FOUNDATION INVESTIGATION REPORT BY:
Gordon, Limited, Consulting Engineers -
Proposed Highway 7 and 15 Underpass,
District 3 (Ottawa) - M.F. 905-64 -

Re: Soil Conditions and Foundations,
Proposed C.N.R. Grade Separation,
Highway 15 and 7,
Ottawa, Ontario.

W.P. 908-64 --
Hwy. #7 and #15,
C.N.R. Underpass,
District #9 (Ottawa).

Re: Hwy. 7 and 15, W.P. 908-64
C.N.R. Underpass - Ottawa

PROPOSED SUBWAY AT MILE 11-65
C.N.R. BEACHBURG SUBDIVISION

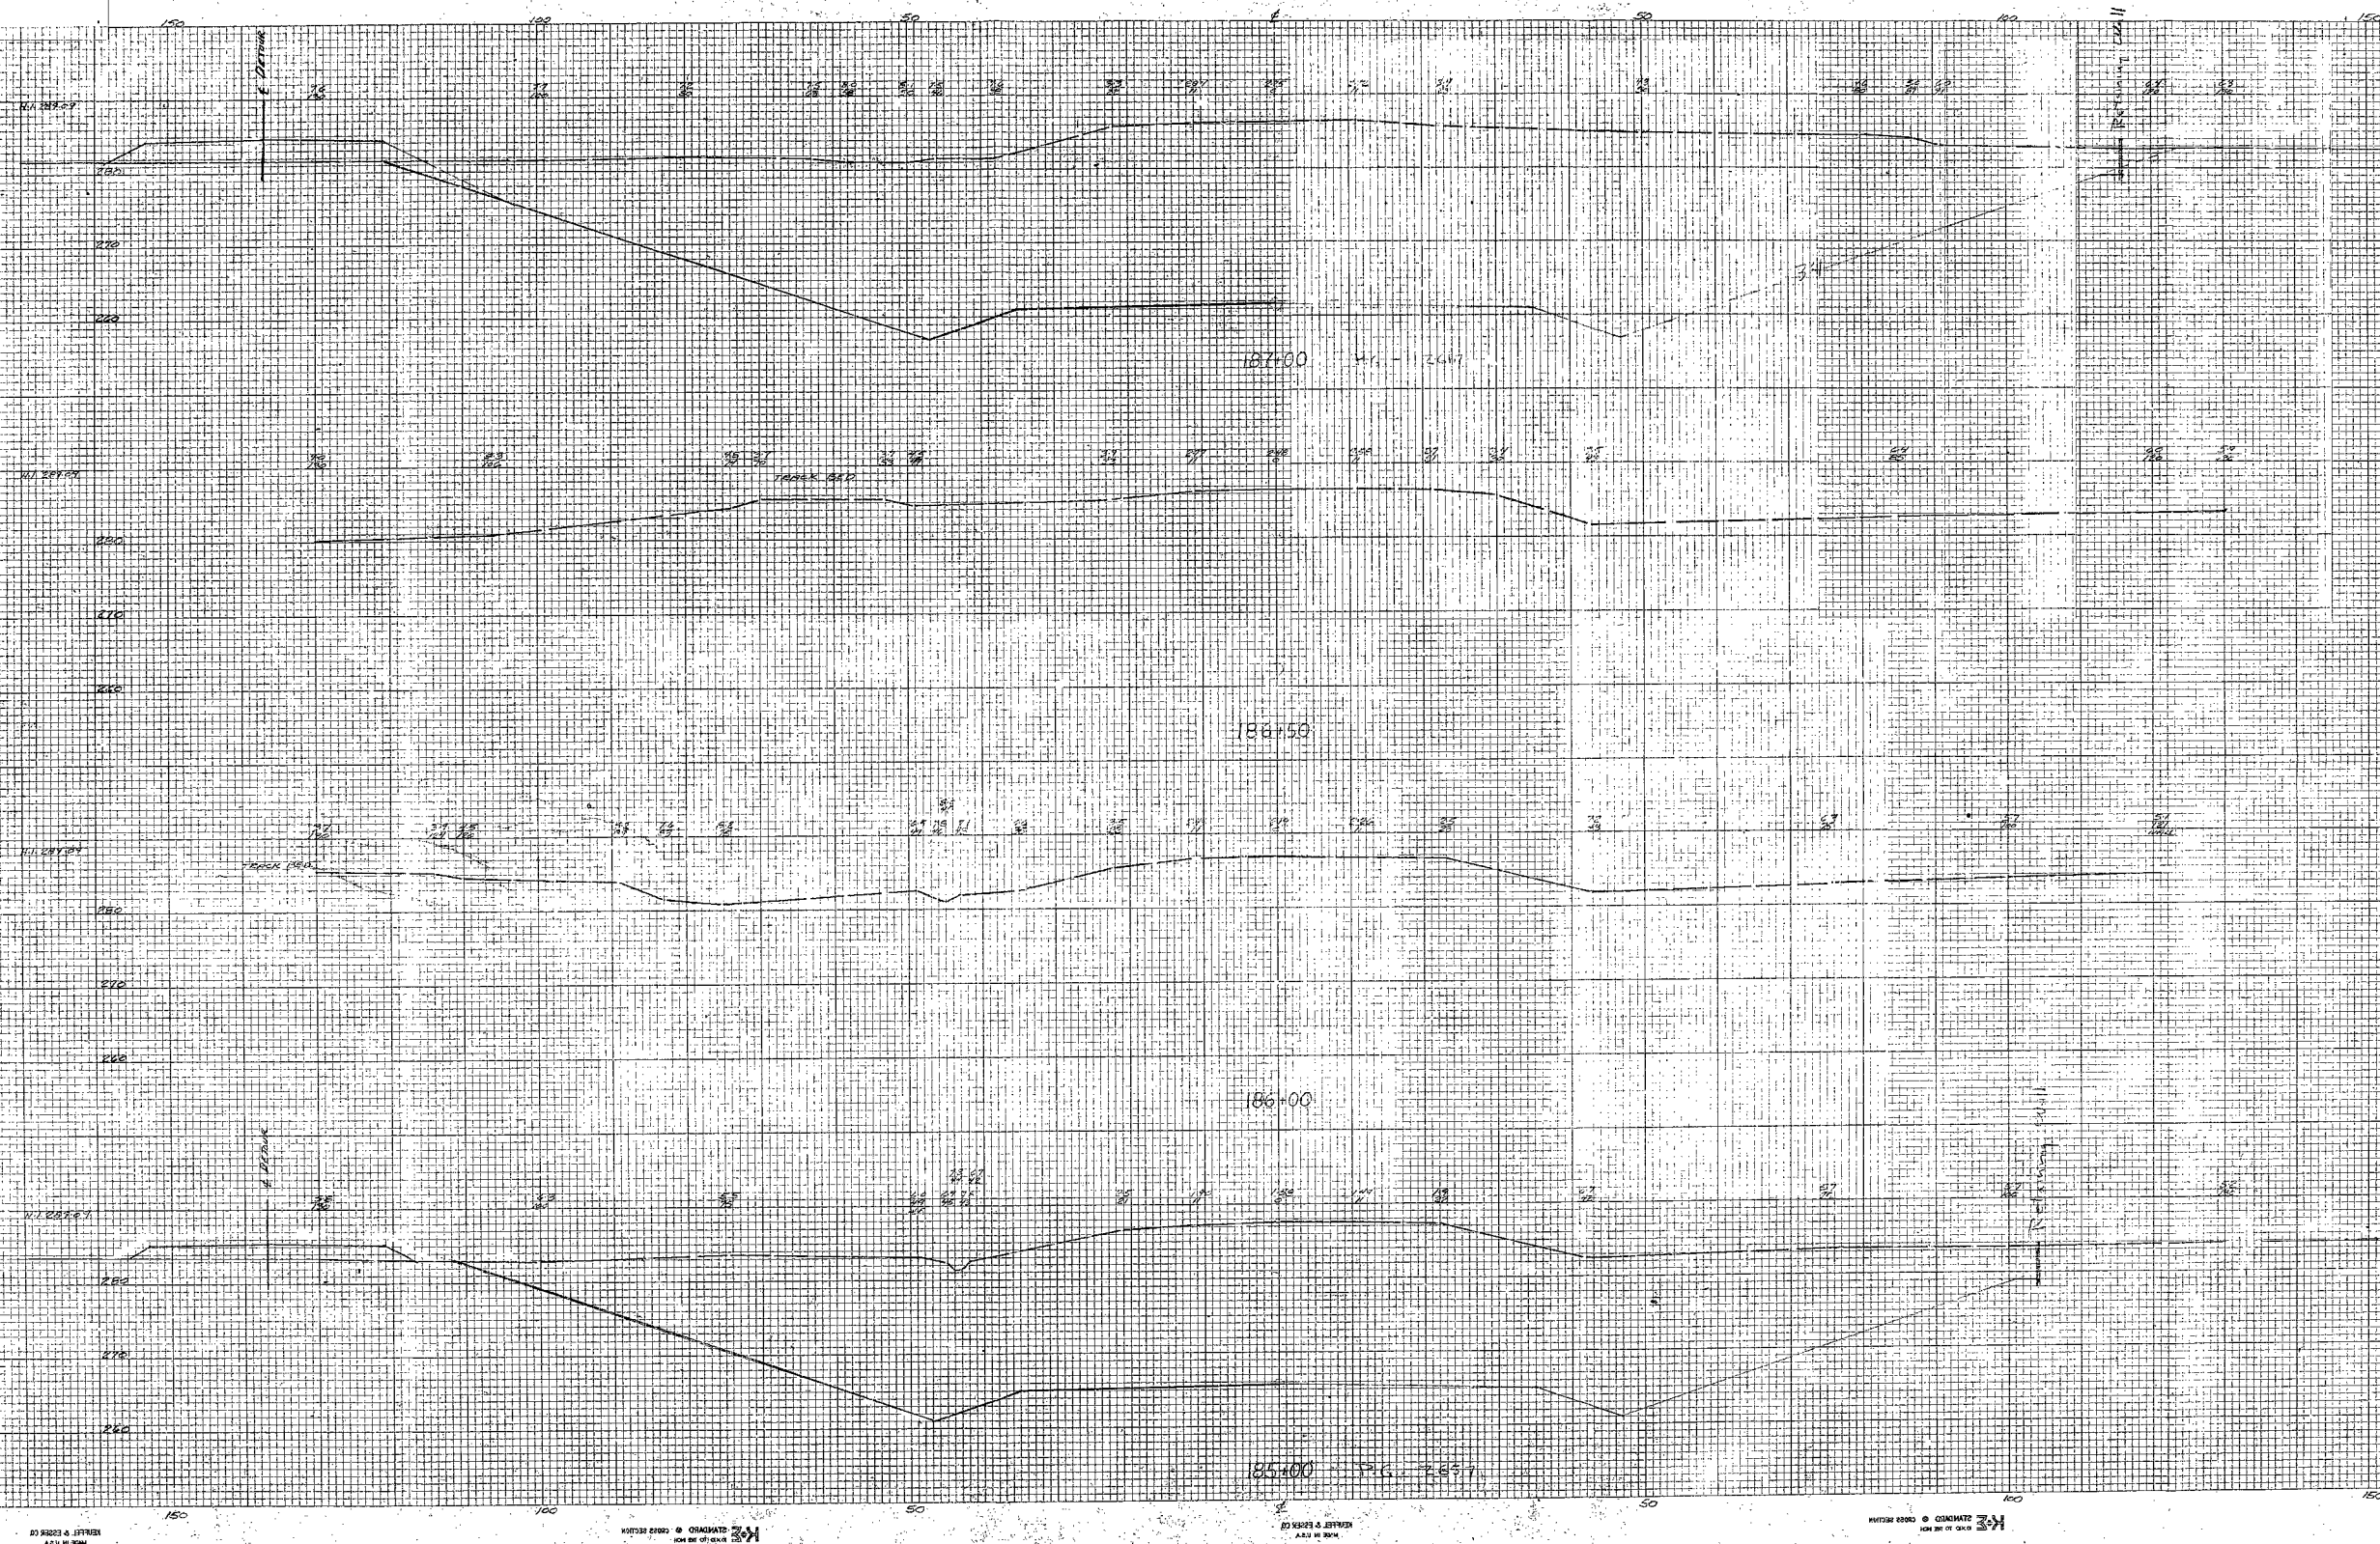
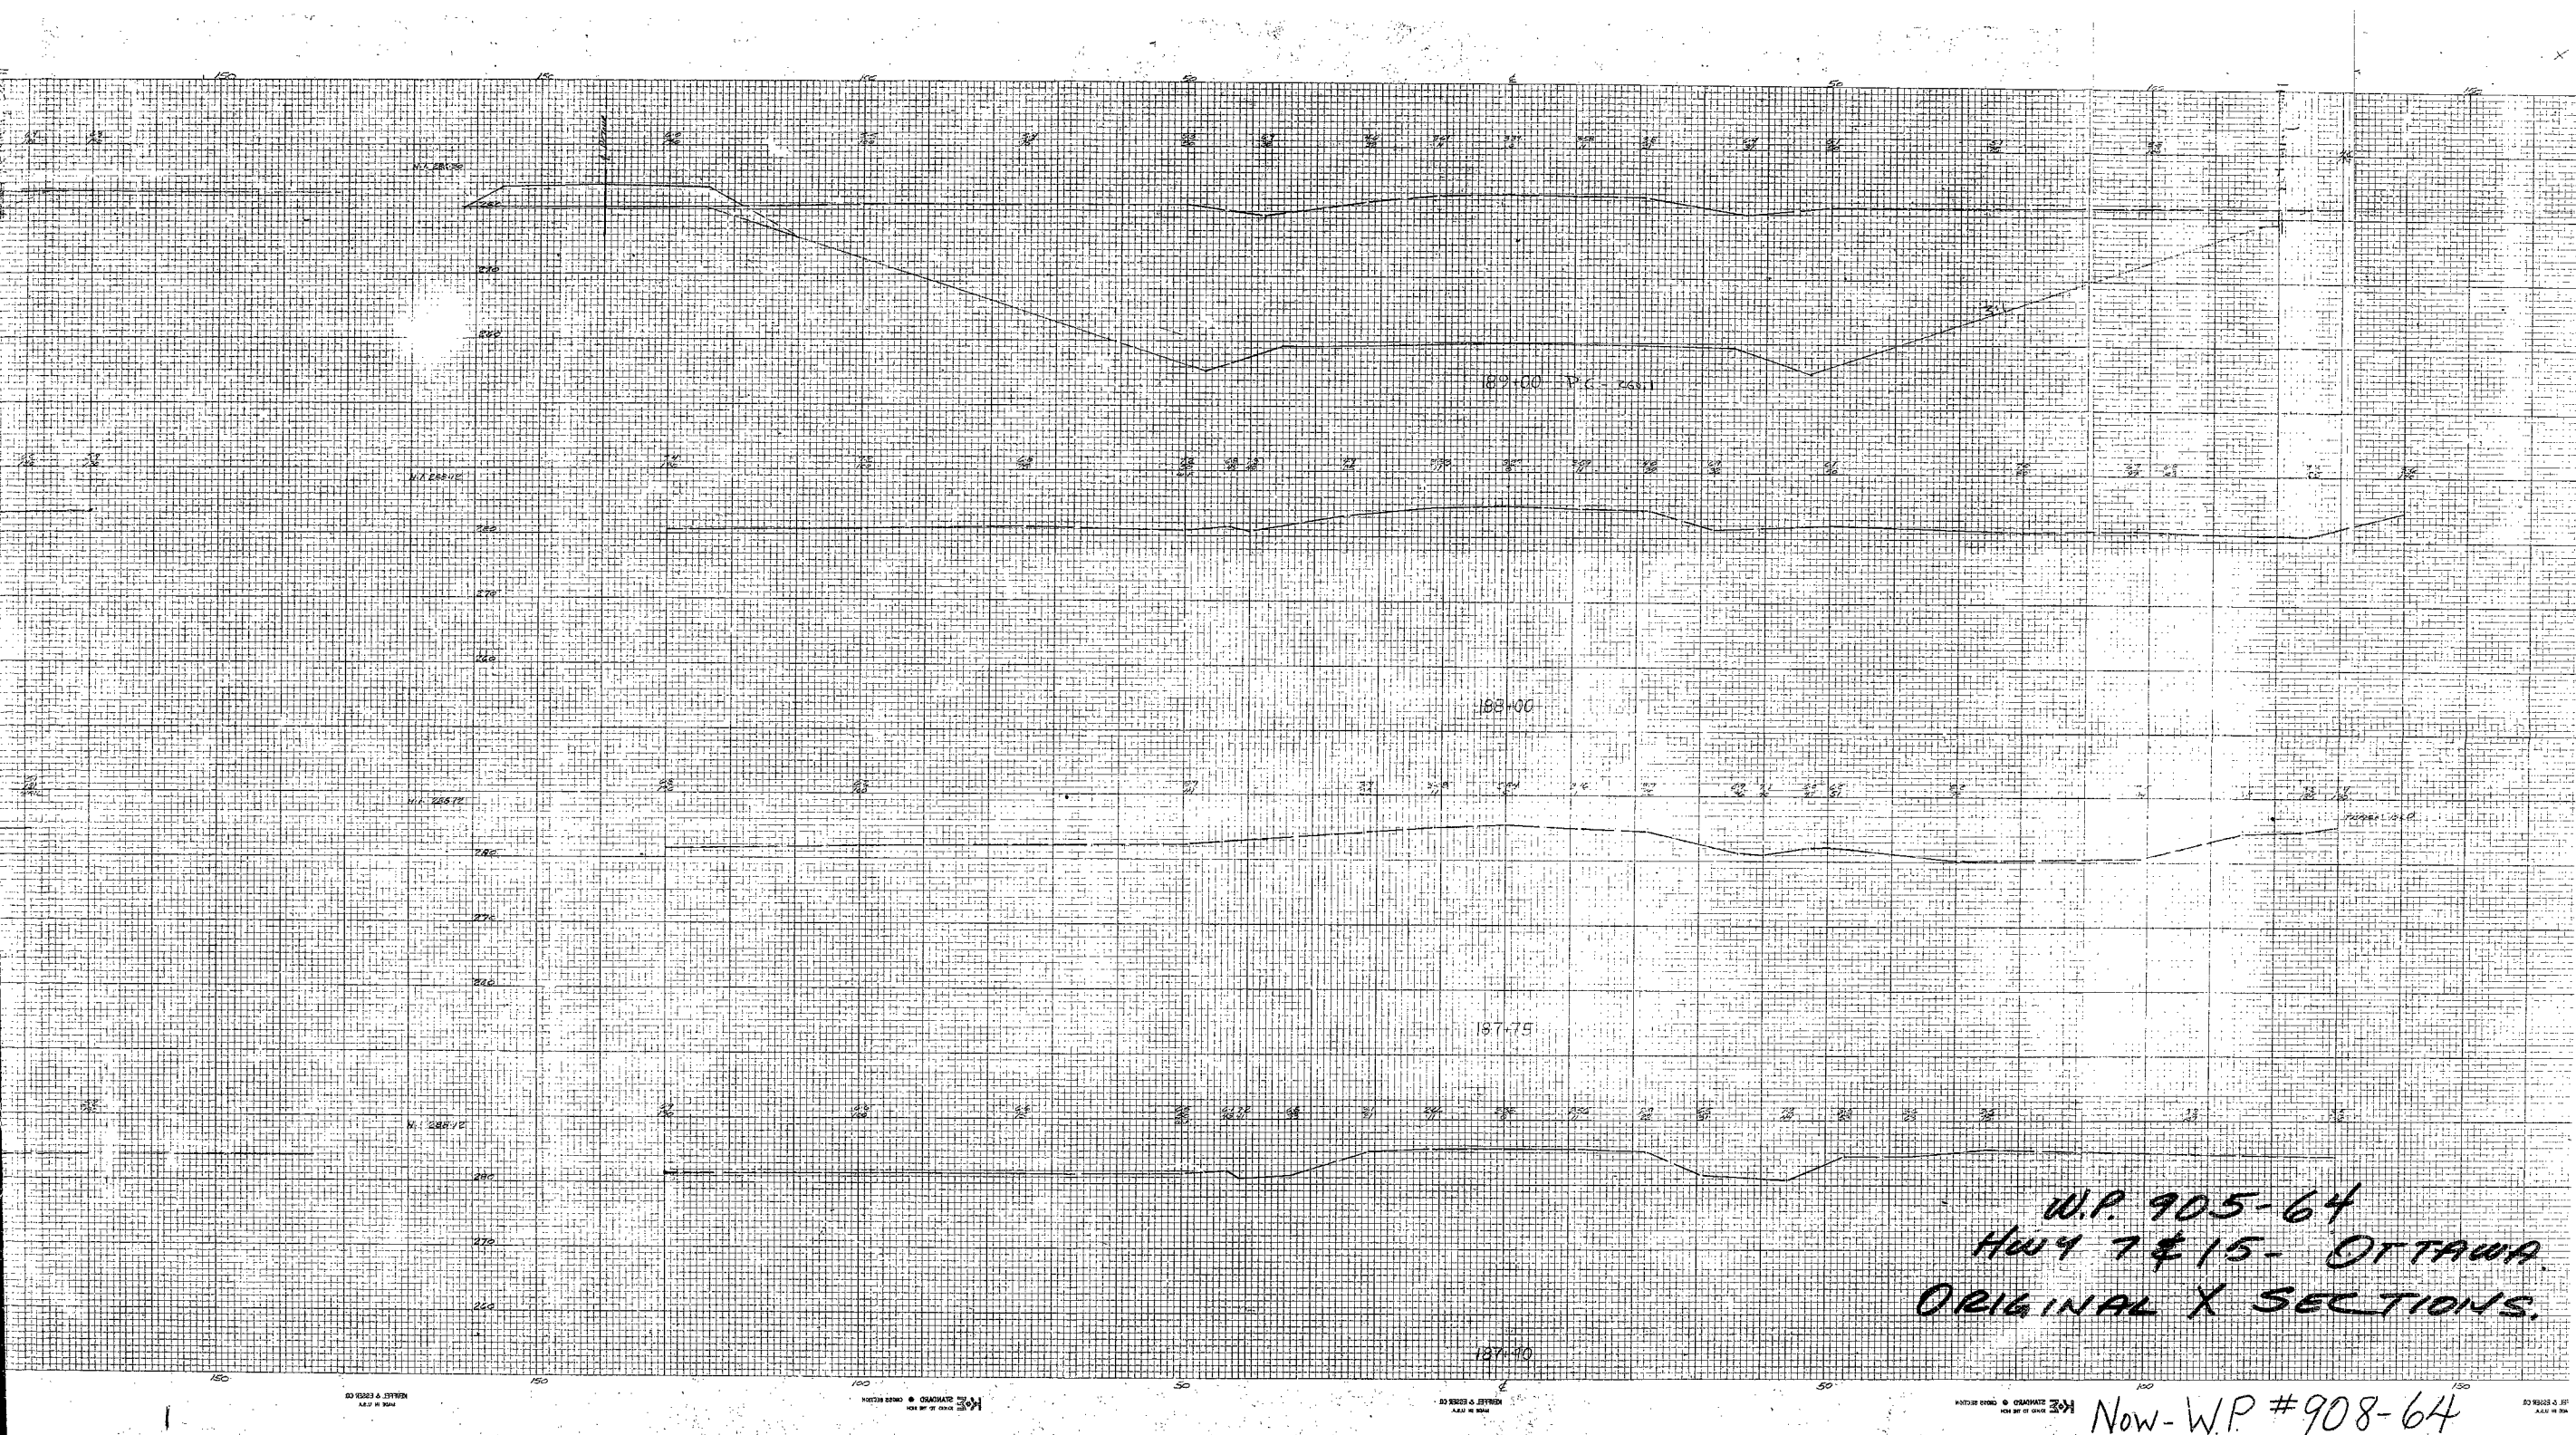
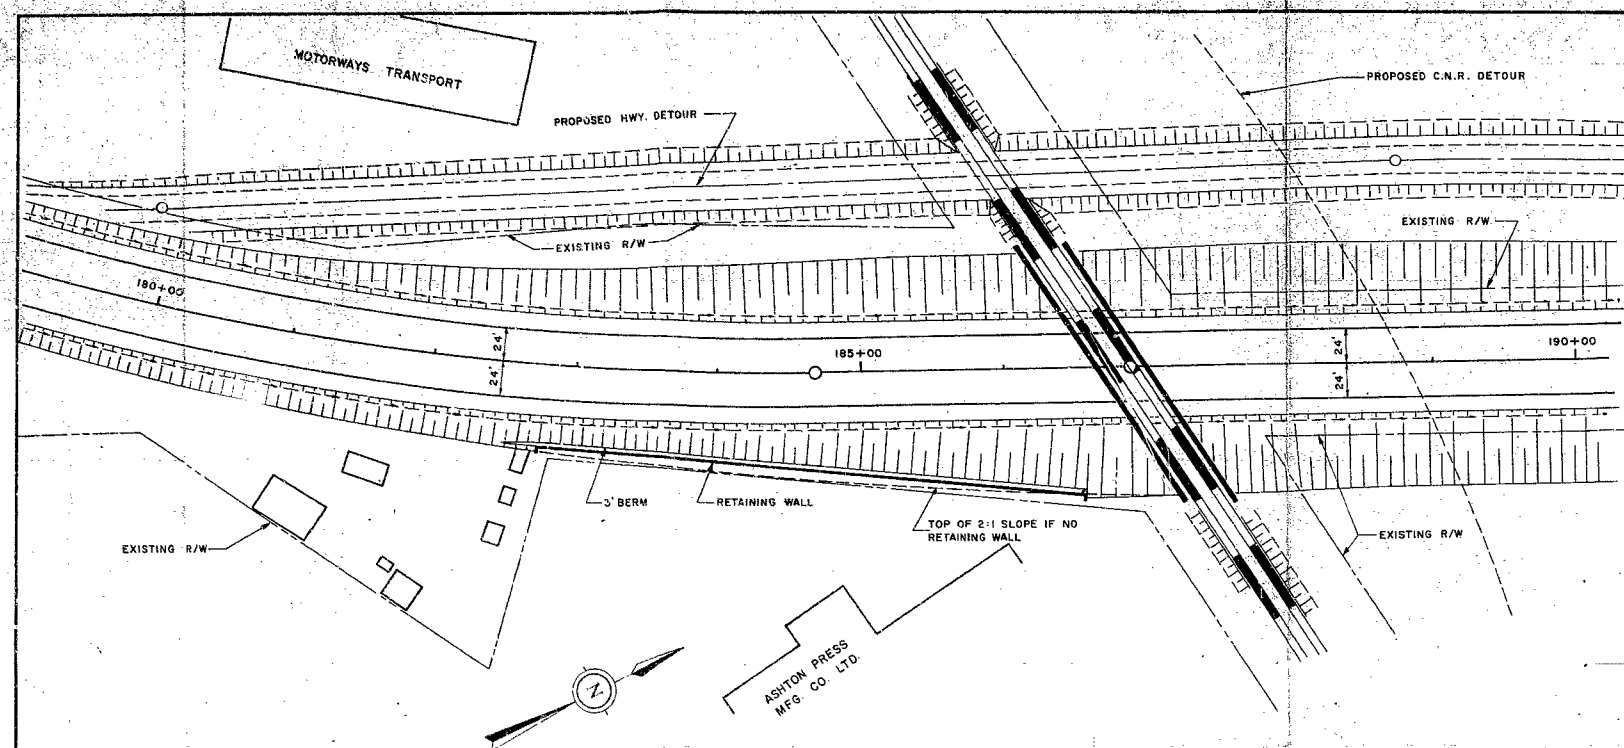
Attached please find a plan indicating the general layout of the proposed highway detour and typical cross-sections of the proposed roadway excavation using 2:1 cut slopes. We have plotted the typical cross-sections on actual original groundline cross-sections, using 3:1 cut slopes as recommended in the foundation report and also the present proposal for the highway detour.

Please advise whether the detour is stable in this proposed location and if not what is the minimum safe distance between the detour centreline and the top of the cut slope.

Following your memo of January 12, 1967, we have reviewed the Foundation Report with regard to the feasibility of constructing the 4-ft. high detour immediately adjacent to a proposed 3:1 cut slope. Based on the stability analyses already carried out, it appears that this small height of fill will have very little effect on the overall stability.
